UNITED STATES PATENT AND TRADEMARK OFFICE

APPLICATION NO.	FILING DATE	FIRST NAMED INVENTOR	ATTORNEY DOCKET NO.	CONFIRMATION NO.
10/780,444	02/17/2004	Peter M. Bonutti	782-A03-023	2789

Office Action Summary	Application No. 10/780,444	Applicant(s) BONUTTI ET AL.	
	Examiner JULIE A. SZPIRA	Art Unit 3731

DETAILED ACTION

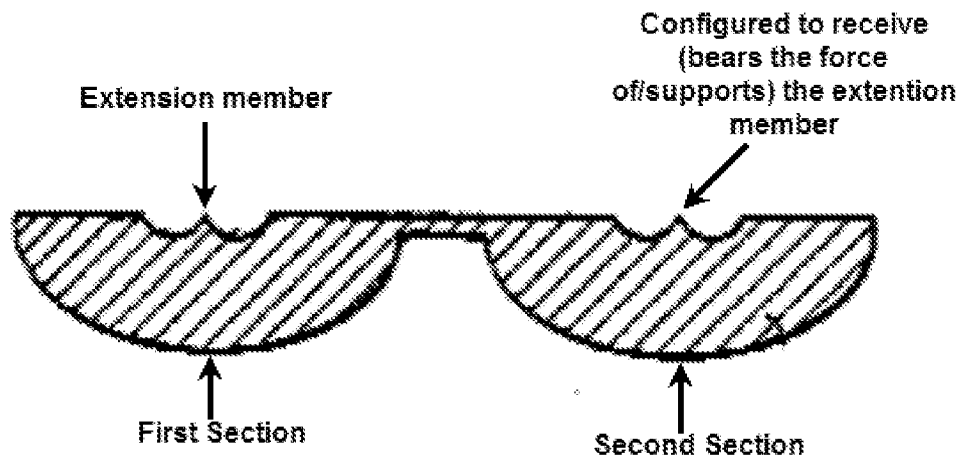
Regarding claims 1, 4, 5, 24, 70, 71 and 77, Egan et al. discloses a device that is capable being implanted and securing an object relative to a body tissue within the body comprising a first section including a first surface and an extension member extending from that surface, and a second section including a second surface opposing the first surface and being configured for receiving the extension member (See Figure Below) the first and second section being bondable together with the application of an

energy source (ultrasonic energy; column 2, lines 27-32 and column 5, lines 23-37), the first surface being configured to abut the object and said second surface being configured to abut the object, said first and second surfaces move closer to each other with the application of the energy source because the extension member shortens (the sections melt, and therefore would mold together, becoming closer) operative to press the object as said first and second sections are bonded together, thereby securing the object within the retainer, whereby the object extends through the fastener in a substantially unobstructed linear fashion (Figures 8 and 12), wherein the first second includes a pair of parallel channels for carrying a first portion of the object in a first of the pair of the parallel channels and for carrying a second portion of the object in a second of the pair of parallel channels (Figure 8; element 112) wherein the extension member is interposed between the pair of parallel channels (see Below).
